Service Bulletin

Bulletin No.: 13-06-01-003A

Subject: Excessive Oil Consumption – Perform Oil Consumption Test and/or Install Piston and Piston Ring Kit

Models: 2010-2013 Buick LaCrosse
2011-2013 Buick Regal
2010-2013 Chevrolet Equinox
2010-2013 GMC Terrain
Equipped with 2.4L Engine (RPOs LAF, LEA)

3409678

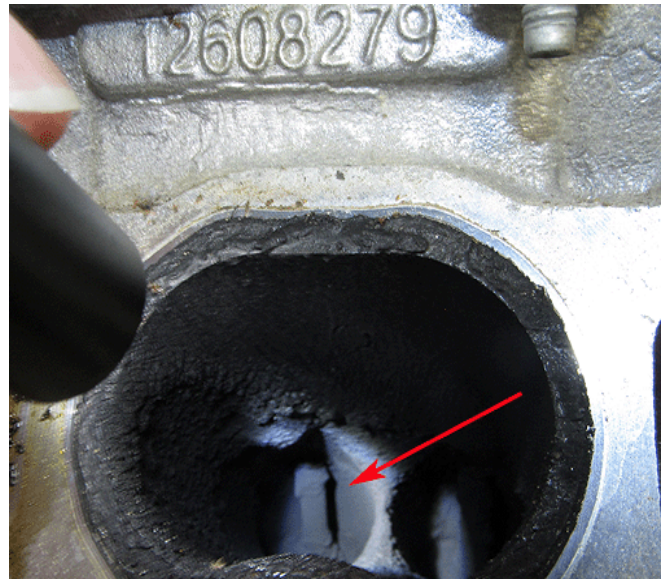
- Camshafts and roller follower will have wear markings. This is normal and do not need to be replaced (refer to picture above).
